AGENDA
HISTORIC DISTRICT COUNCIL
REGULAR MEETING
SEPTEMBER 19, 2024
5:00 PM
CITY HALL COMMISSION CHAMBERS
204 ASH STREET
FERNANDINA BEACH, FL 32034

HISTORIC DISTRICT COUNCIL STAFF REPORT
HDC 2024-0020
SEPTEMBER 19, 2024

CITY OF FERNANDINA BEACH
LOT C AND D
AMELIA RIVER WATERFRONT PARK
NEW OPEN PAVILION

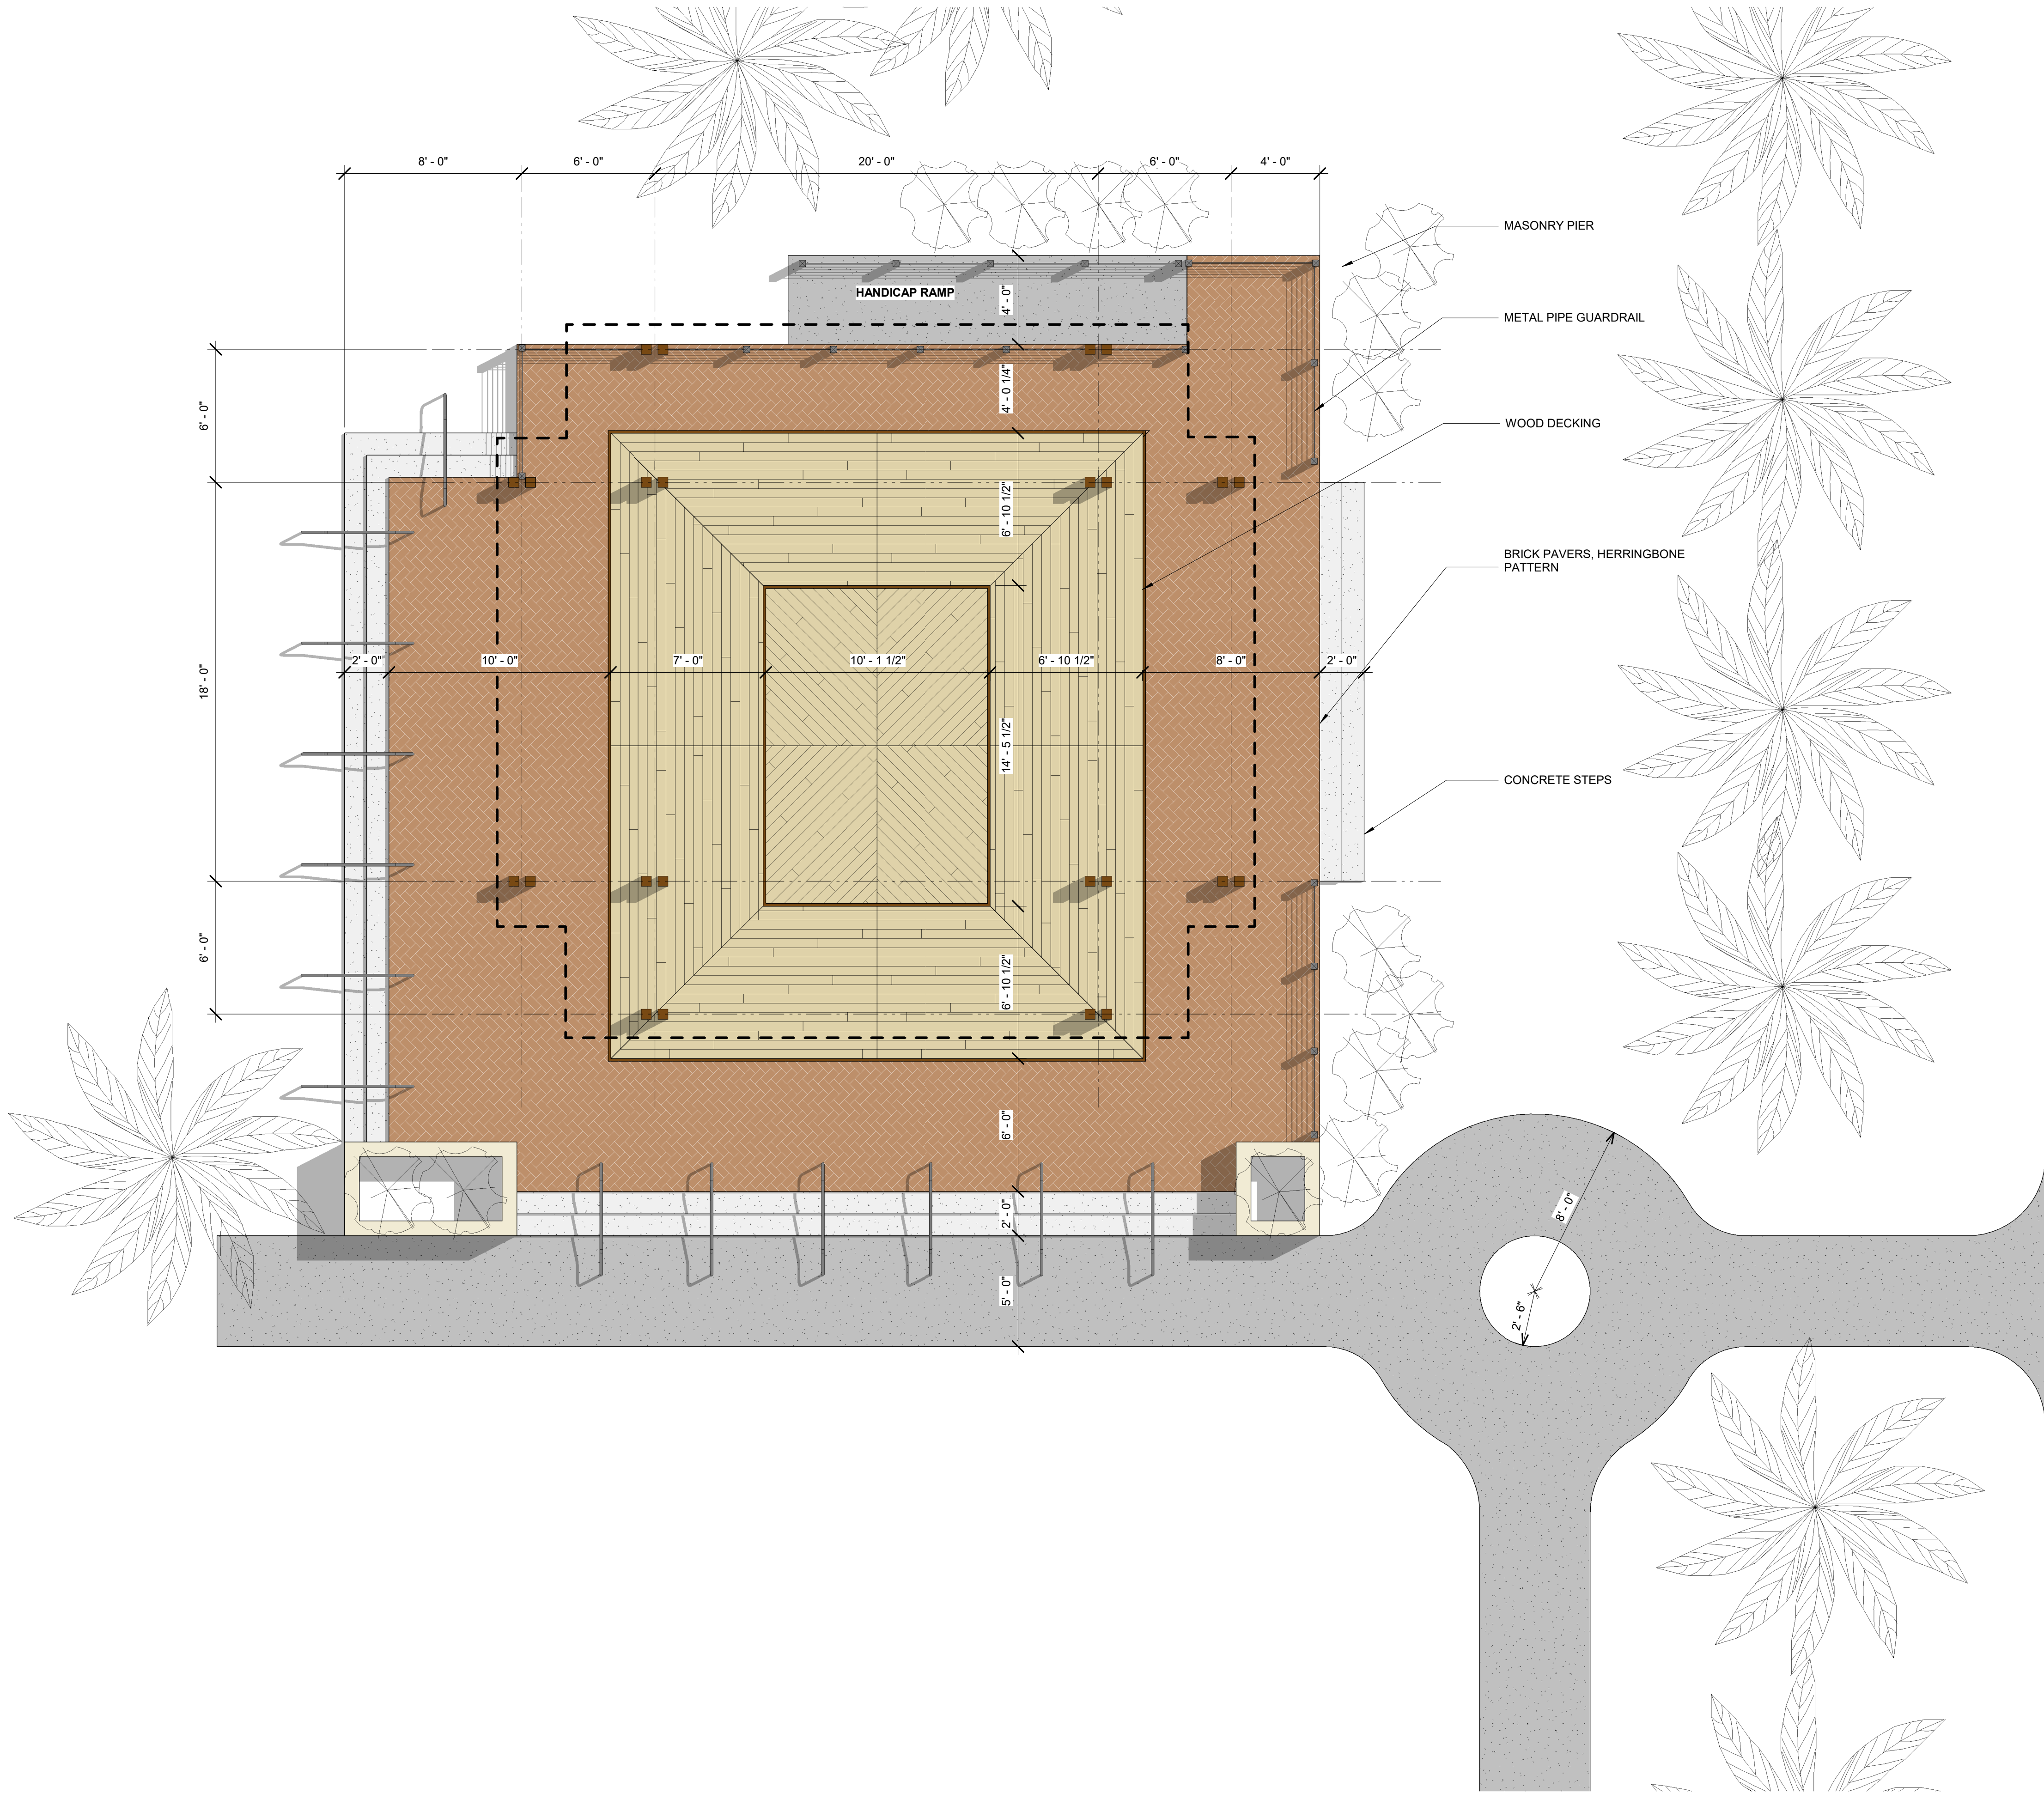
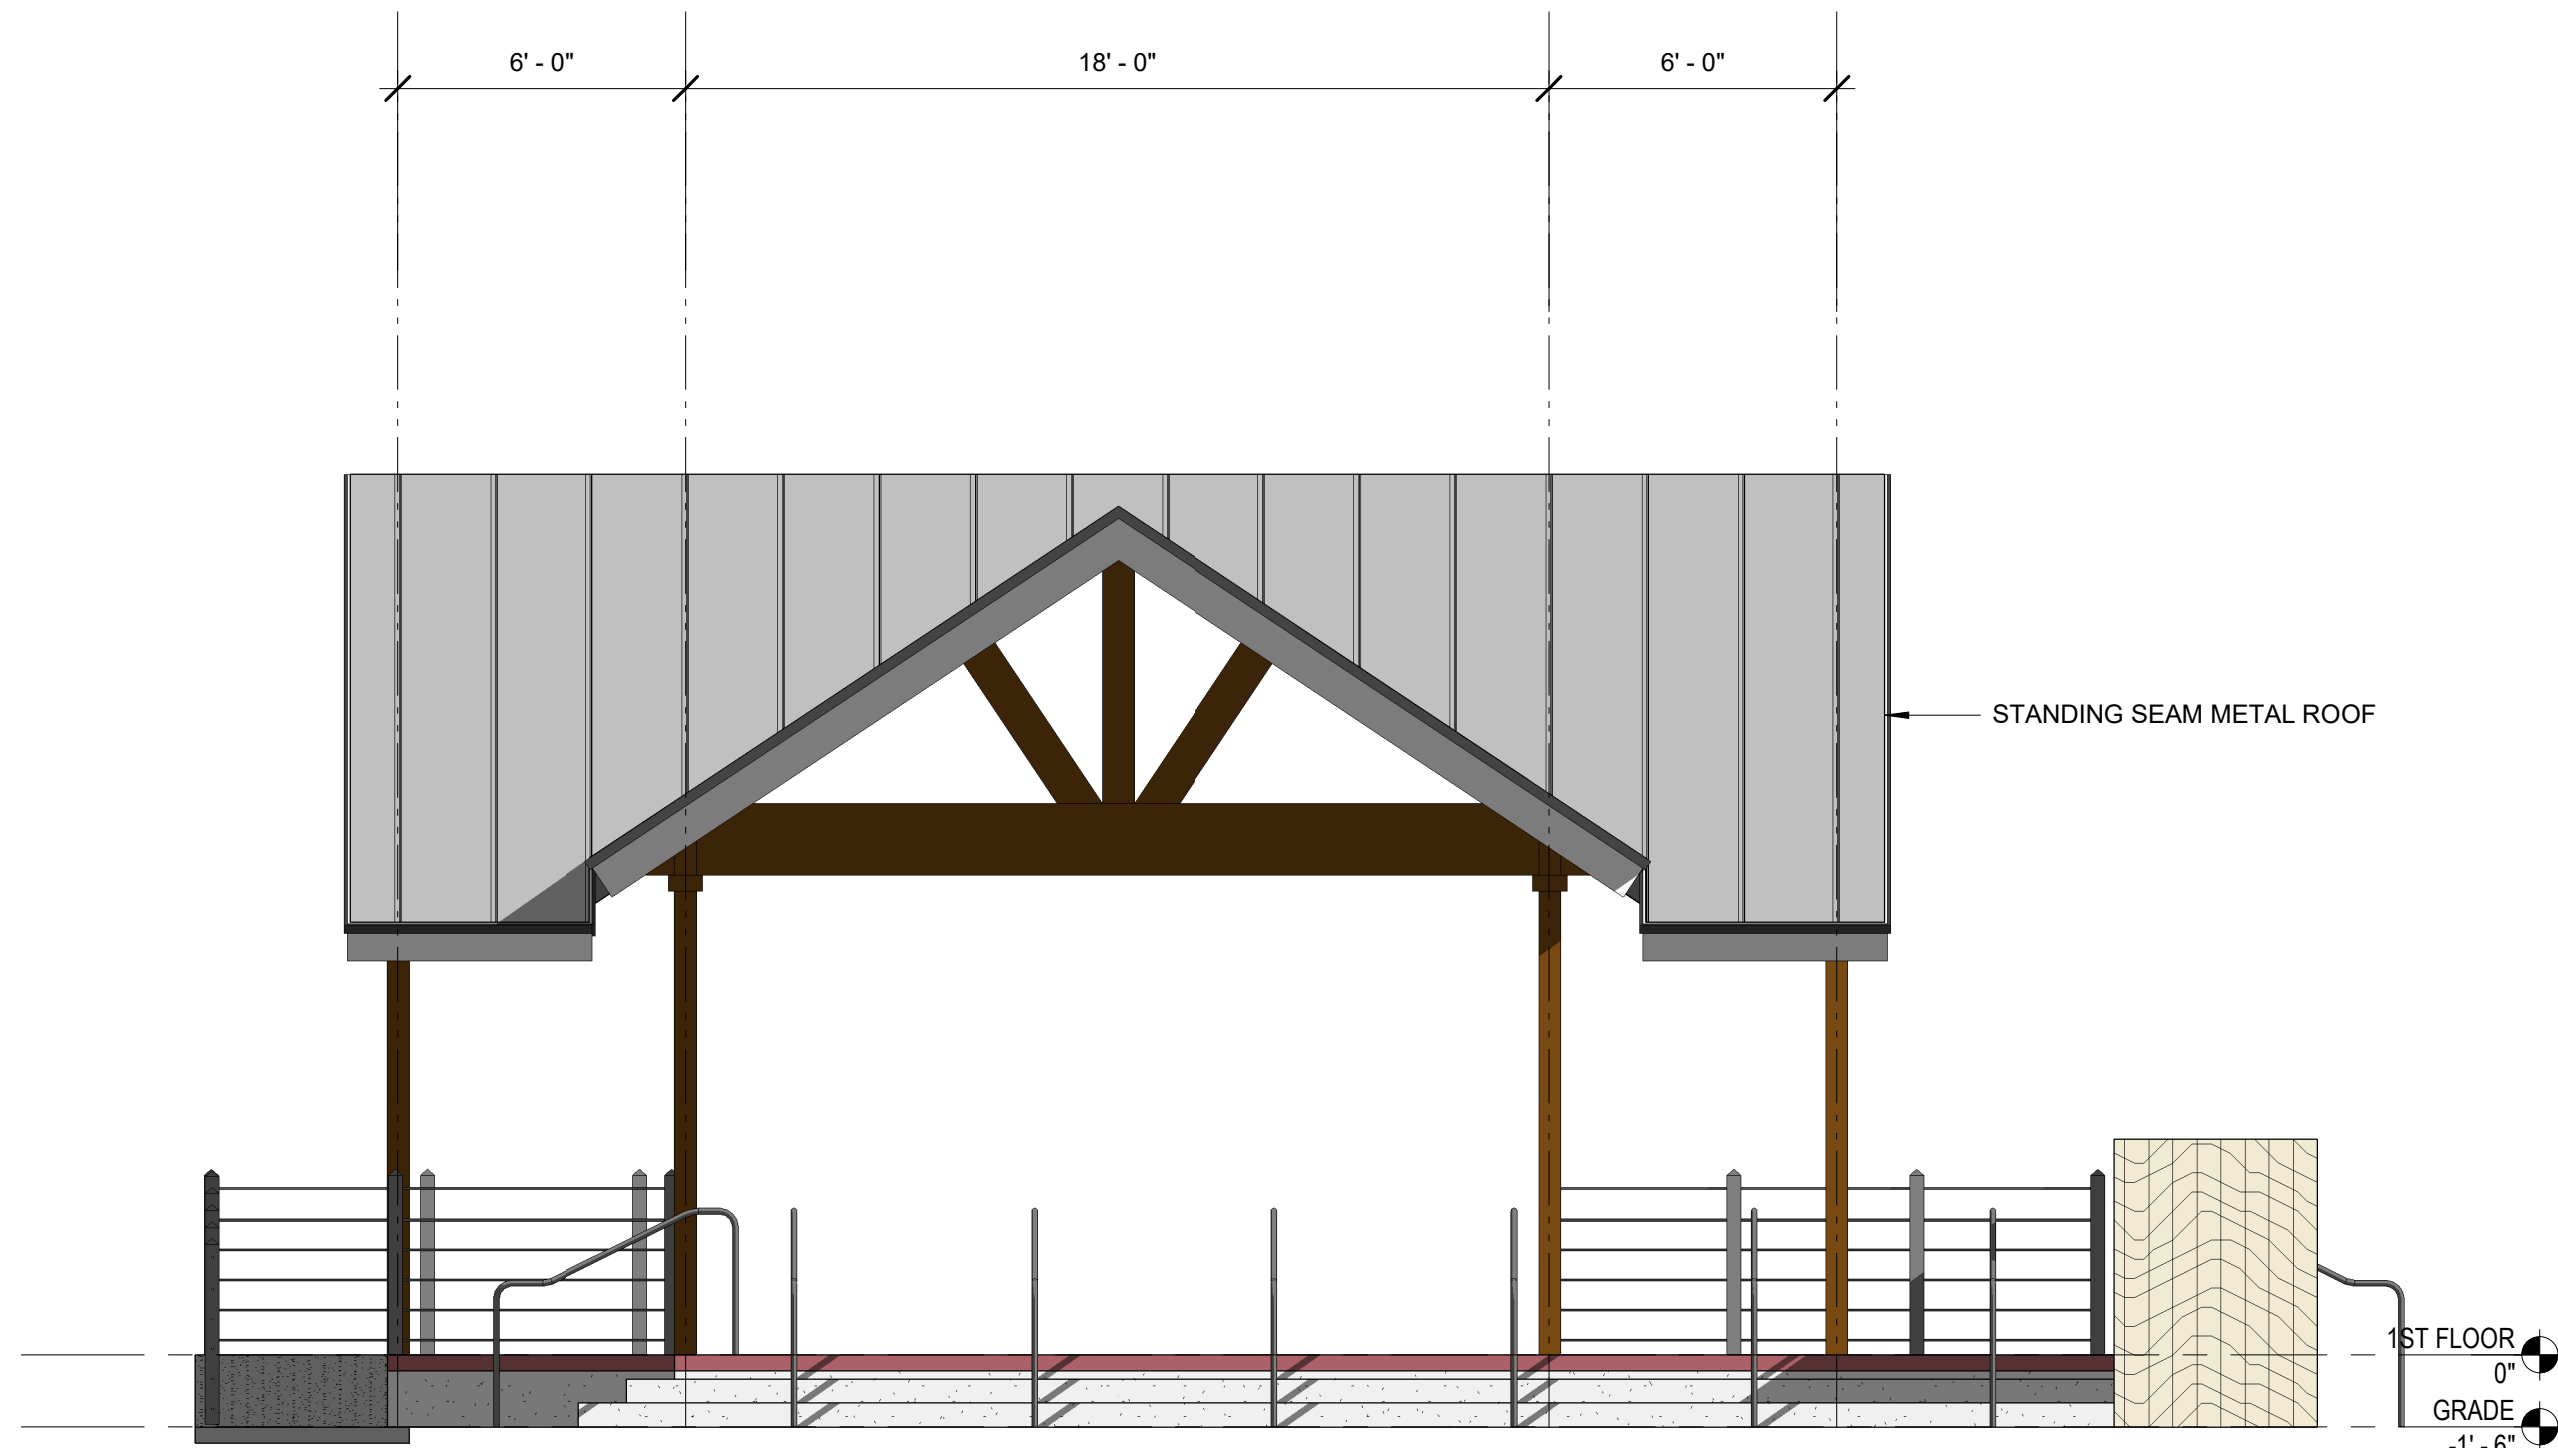
Lisa Finkelstein, Chair of the CRA Advisory Board, addressed the concerns of the Board at the June 27, 2024, previous meeting. She noted the removal of the concrete planters, the spoke of the height concerns, the ramp, the

bracketing style, the railing cabling, the wood stamped concrete, the flooring materials, and a larger landscape plan.

The Board discussed these proposed modifications further and suggested simplifying the design, which in turn would reduce costs and help better integrate the structures into the existing environment. They also asked to consider that the final pavilion design ties in with the upcoming Atlantic Seafood project design.

The design of the waterfront and these elements have not been provided to the TRC for technical consideration. This is a necessary next step which must be completed before the issuance of any building permits.

DESIGN OBJECTIVE	To create an architecturally iconic pavilion that reflects the Victorian architecture of Fernadina's Historic District (lap siding, steeply pitched roofs) combined with a working waterfront aesthetic (metal roofs, minimal ornamentation, maritime references), consistent with the CRA Design Guidelines.
COMPATIBILITY	These recommendations will make the pavilion & restroom building architecturally compatible.
SITE PLAN	Site plan shows stairs on the west side overlapping the floodwall. Adopt CRAAB pavilion floor plan and site plan
BUILDING HEIGHT	25' from grade.
ROOF	PITCH - 12/12. EAVES - Bottom edge of roof should align around all four sides. OVERHANGS - 18" minimum. STANDING SEAM METAL - Style and color OK. GUTTERS & DOWNSPOUTS (or rain chains) - Add at each corner. Downspouts should go through the deck to ground below. (Match to Train Depot pavilion gutters and downspouts). SKYLIGHTS - Add four skylights to north/south roof near junction of east west dormers, to bring light into the interior.

GABLES	To reduce rain incursion into the pavilion and to make the design compatible with Historic District architecture, infill gable ends with lap siding and triangular openings at top of gables for light and air flow. Infill south gable end with a circular opening in the lap siding. (Circular opening establishes the front of the pavilion and is a metaphorical sunset).
COLUMNS	8x8s, no double columns.
DECK	Remove northwest corner of deck per CRAAB floor plan. Brazilian Ipe wood decking OK. Eliminate brick and make entire deck Ipe.
STAIRS	Concrete Steps and Edge Ribbon OK. Three steps with 7" risers, so deck height is 21". (Since pavilion will be used for stage performances, increased height of the stage and deck is needed).
ADA RAMP	Should be 21' long x 5' wide. Ramp will also be used to move equipment for stage performances, so wider width is necessary.
RAILINGS	Cable OK, with 4x4 posts. Add minimal top rail.
